From: John.Wooldridge@dot.ohio.gov [mailto:John.Wooldridge@dot.ohio.gov]
Sent: Friday, June 05, 2020 11:08 AM
To: James Howard; Chris E. Howard
Cc: Kimber.Heim@dot.ohio.gov; Harvey.Norton@dot.ohio.gov
Subject: 110412 FAI 037 Safety Project D5 Requests Cost Proposal ASAP

Subject: RE: FAI-37-6.34 Preliminary Right of Way Plans (PID No. 110412)

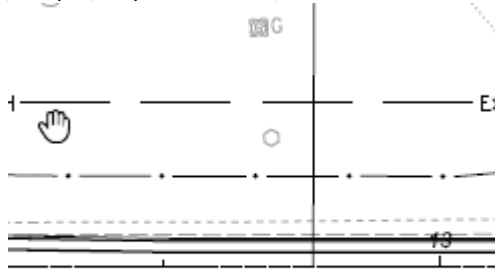
- Missing sheet 20 of 37 as Luke stated.
- Page 21/36 (22/37) Parcel 11-SH shows "Utility Pole Save" for private light poles. I would have them removed as ODOT will need to pay for them anyways (in take area) and would need to do a permit (not recommended) for the poles that are very close to the fence needing removed. Same Parcel has three of those poles (not 2) and also has a small sign near the fence that was not picked up on these plans:
